<b>DOCKETED</b>	
<b>Docket Number:</b>	19-BSTD-03
<b>Project Title:</b>	2022 Energy Code Pre-Rulemaking
<b>TN #:</b>	235645
<b>Document Title:</b>	Home Ventilating Institute Comments - Response to CEC's Nov 3 Proposal to Establish Minimum Prescriptive Requirements for HERVs
<b>Description:</b>	*** This document supersedes TN 235641 ***
<b>Filer:</b>	System
<b>Organization:</b>	Home Ventilating Institute
<b>Submitter Role:</b>	Public
<b>Submission Date:</b>	11/17/2020 2:11:25 PM
<b>Docketed Date:</b>	11/17/2020

**HVI Comment - Docket No 19-BSTD-03; Response to CEC's Nov 3  
Proposal to Establish Minimum Prescriptive Requirements for  
HERVs**

Re: Docket No. 19-BSTD-03, 2022 Energy Code Pre-Rulemaking; *Response to CEC's November 3<sup>rd</sup> Proposal to Establish Minimum Prescriptive Requirements for H/ERVs*

**Figure 1.** A regression of HVI’s H/ERV CPD shows that an SRE of 67 is correlated to an ASRE of 72.

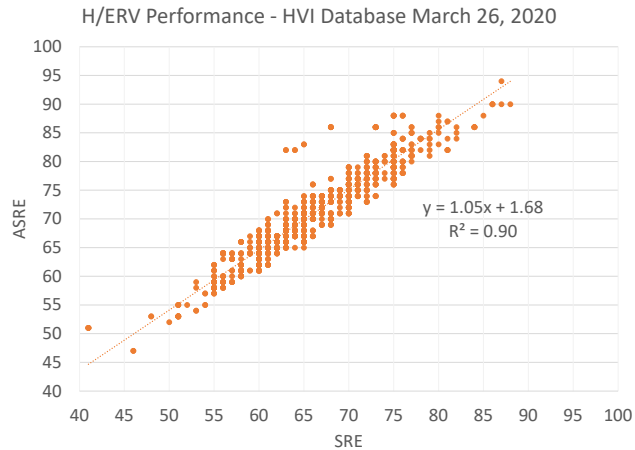
- c. Modification 3: use an Adjusted Sensible Recovery Efficiency (ASRE) when modeling the heat recovery effectiveness of an HVI certified H/ERV, not a Sensible Recovery Efficiency (SRE). The CASE team used a sensible recovery efficiency (SRE) of 67 in their simulations, selected as a value achieved by the majority of H/ERVs in HVI's Certified Product Database (CPD). However, the best metric available to model the performance of an HVI-certified H/ERV when fan energy is calculated separately from heat exchanger performance (as is done within California Building Energy Code Compliance [CBECC] software and EnergyPlus software) is the rated ASRE at a temperature of 32°F. Following is HVI Publication 920's definition of ASRE that is applicable to the rated ASRE at 32°F and that clarifies HVI's recommendation to use an ASRE when conducting building energy simulations:

Communications with CEC staff and Bruce Wilcox on March 27, 2020 confirmed that CEC staff also support the use of ASRE when simulating H/ERV performance in CBECC. Based on a regression of SRE and ASRE values of H/ERVs in the HVI CPD, an SRE of 67 is correlated with an ASRE of 72 (see Figure 1). HVI therefore recommends that CASE's simulations be modified to use an ASRE of 72 when simulating heat exchanger effectiveness.

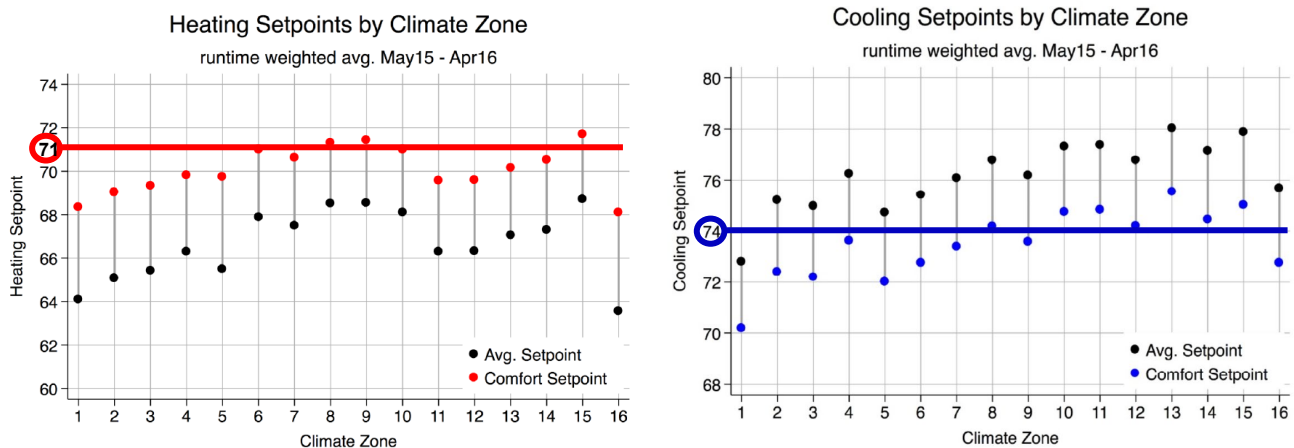
- d. **Modification 4: use thermostat setpoints that are better aligned with occupied setpoints in California homes.** CBECC currently uses a thermostat heating setpoint of 60°F for 8 hours per day and 68°F for 16 hours per day. CBECC’s thermostat cooling setpoint is a constant 78°F in cooling. These setpoints are far more conservative than setpoints assumed by ASHRAE 90.1, IECC, or those documented by a recent study of thermostat setpoints in California homes. As such, CBECC’s setpoints discount the heat recovery benefit of H/ERVs that when modeled within CBECC. A 2016 study conducted by Nest<sup>3</sup> across 150,000 California residential thermostats and 13 million days of data identified a thermostat “comfort set point” in heating and cooling, which was the “typical setting when people are home and want to be comfortable”. Arguably, occupancy and comfort-driven behavior are reasonable bases for establishing thermostat setpoints for a building energy standard. Because it is an occupied comfort setting, the comfort setpoint identified by Nest is higher than the average setpoint and is determined as “the 90<sup>th</sup> percentile of the customer’s heating set points and the 10<sup>th</sup> percentile of their cooling set points” for each climate zone. The state-wide comfort setpoints attributed to the Nest study in Table 2 are values that have been developed by applying a multifamily-starts weighting factor for each climate zone (derived from CEC data) to the Nest study’s comfort setpoint for each climate zone. Figures 2 and 3 show both the average and comfort heating and cooling setpoints for each climate zone (Nest data) as well as estimated, weighted state average heating and cooling setpoints (developed from post-processed Nest data). While HVI recommends the use of occupied comfort setpoints for CBECC analysis, it is clear even from the average thermostat setpoints in the Nest data that CBECC’s thermostat heating setpoint should be revised upward and CBECC’s cooling thermostat setpoint should be revised downward, resulting in greater energy savings for H/ERVs than predicted by the CASE study.
